Planning Commission Staff Report

February 22, 2017
Item 5.a.

- SUBJECT:** Vesting Tentative Map 8352
- APPLICANT/
OWNER:** GHC Lund Ranch, LLC
- PURPOSE:** Application for a Vesting Tentative Tract Map to subdivide an approximately 194.7-acre property into 46 lots for 43 single-family homes (approved under PUD-25) and three lots to be dedicated to the City of Pleasanton for permanent open space.

Figure 1: Proposed Vesting Tentative Map (Tract 8352)

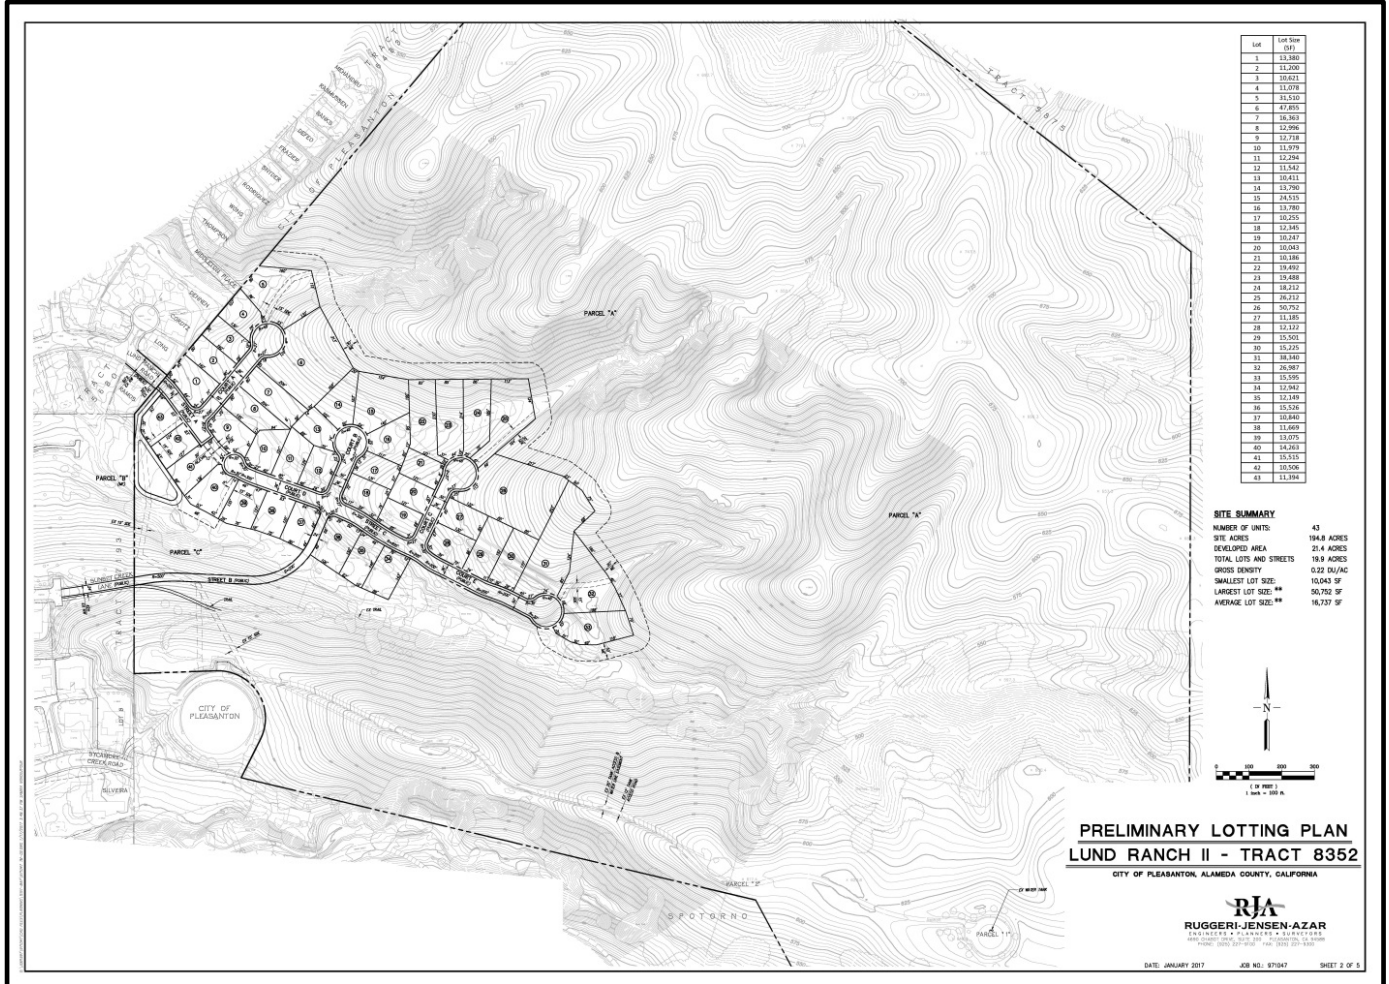
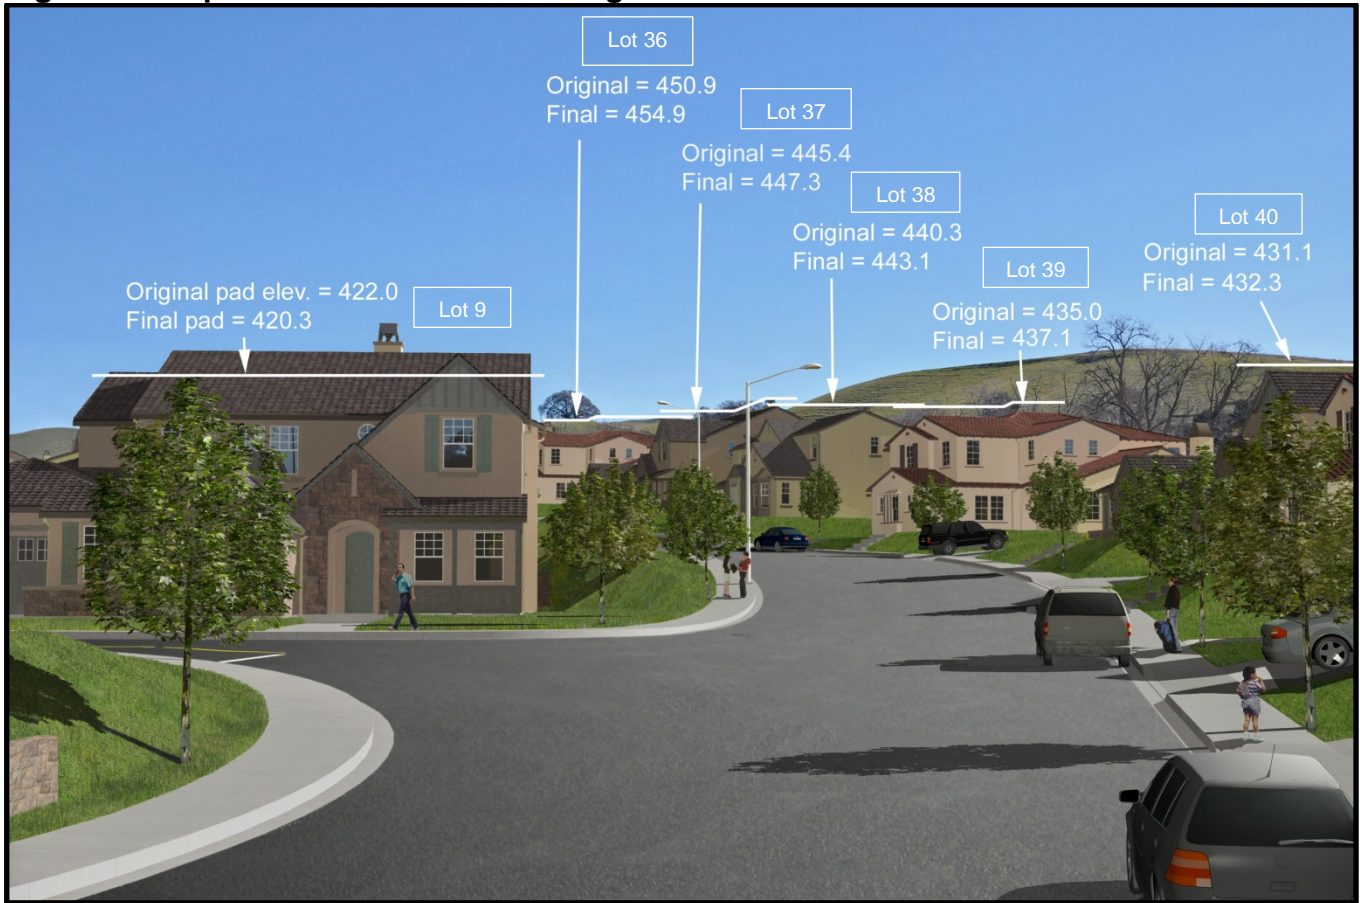
1. The pad elevations for some of the lots would decrease or increase approximately 1 foot to 5 feet in height. The most visually noticeable changes will occur primarily within the central to eastern portions of the project and not on the lots abutting the adjacent residential neighborhoods to the west. These changes are a result of the elimination of seven lots proposed along “Court E” during the PUD review and approval process. The elimination of these lots caused the cut and fill earthwork initially proposed for the project to become out of balance by approximately 30,000 cubic yards. Thus, without the proposed grading changes, the excess soil would have to be off-hauled with trucks through the adjacent residential neighborhoods to the west. The proposed grading changes allow for the excess soil/cut material created by the project to be redistributed on-site rather than being off-hauled. Generally speaking, on hillside developments, smaller trucks are used for off-hauling and can carry approximately nine cubic yards of off-haul material per trip (standard trucks can carry 16 to 18 cubic yards of off-haul material per trip); therefore, the proposed grading changes would eliminate approximately 3,333 off-haul truck trips through the adjacent residential neighborhoods to the west. Figure 2 (below) is the visual simulation prepared for the PUD plan from a viewpoint at the terminus of Lund Ranch Road; the white lines depict changes in building elevations resulting from the currently-proposed change in pad elevations. In Figure 2 (below), the pad elevations for Lots 1 through 5 will decrease by approximately 0.1 to 1.2 inches, and the pad elevation for Lot 43 will increase by approximately 1 foot, 1 inch. The pad increase for Lot 43 will have minimal visual impact and is within a typical height deviation created when project plans and calculations are refined between the PUD and VTM stages.

Figure 3: PUD Approved Versus VTM Proposed Street B Alignment

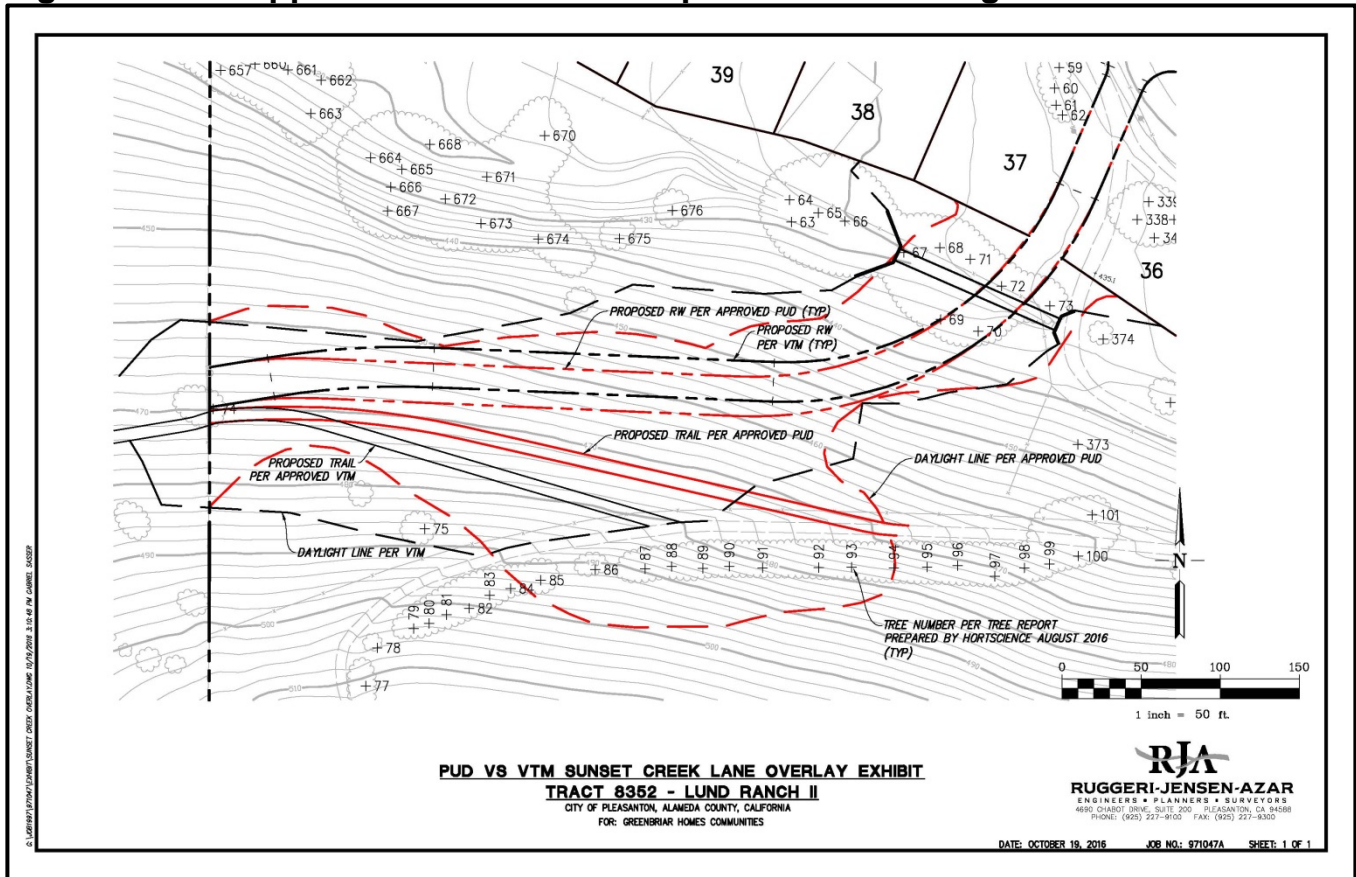
2. The alignment of Street B, which connects Sunset Creek Lane to the project, has been modified pursuant to the PUD conditions of approval to reduce a number of impacts associated with the previous PUD, including grading within areas with a slope greater than 25%, cut and fill associated with the road improvements, and removal of Heritage Trees.

- The PUD approved road alignment and the VTM proposed road alignment;
- The PUD approved trail (pedestrian connection) alignment and the VTM proposed trail (pedestrian connection) alignment;

- Seven Heritage Trees (Nos. 67 through 73) that were approved to be removed as part of the PUD, and are adjacent to the culvert, under Street B; and
- 10 olive trees (Nos. 85 through 94), five of which are Heritage Trees, that were approved for removal under the PUD, and would now be preserved under the proposed road alignment. The Heritage olive trees that would be preserved under the VTM are a prominent visual feature of the north-facing hillside, and are visible from the Lund Ranch project site and Bonde Ranch Open Space to the north. In addition, the VTM would result in the removal of a non-Heritage olive tree (No. 75) not approved for removal under the PUD. Staff notes that no other tree removals have been altered in the rest of the site as part of the VTM.

- The realignment of Street B reduces a number of impacts, including: reducing the amount of grading on slopes greater than 25% from 0.8 to 0.6 acre; reducing the overall amount of cut and fill associated with grading for the street from 5,800 cubic yards of cut to 4,250 cubic yards of cut and 6,700 cubic yards of fill to 5,860 cubic yards of fill, respectively; and reducing the number of Heritage Trees to be removed to include 10 olive trees (including five Heritage Trees) that would be preserved on the north-facing hillside where Street B would connect the project to Sunset Creek Lane. These changes are consistent with City Council direction that the road connection be the least environmentally significant alignment possible, as required by PUD Condition of Approval 1c (Exhibit C).
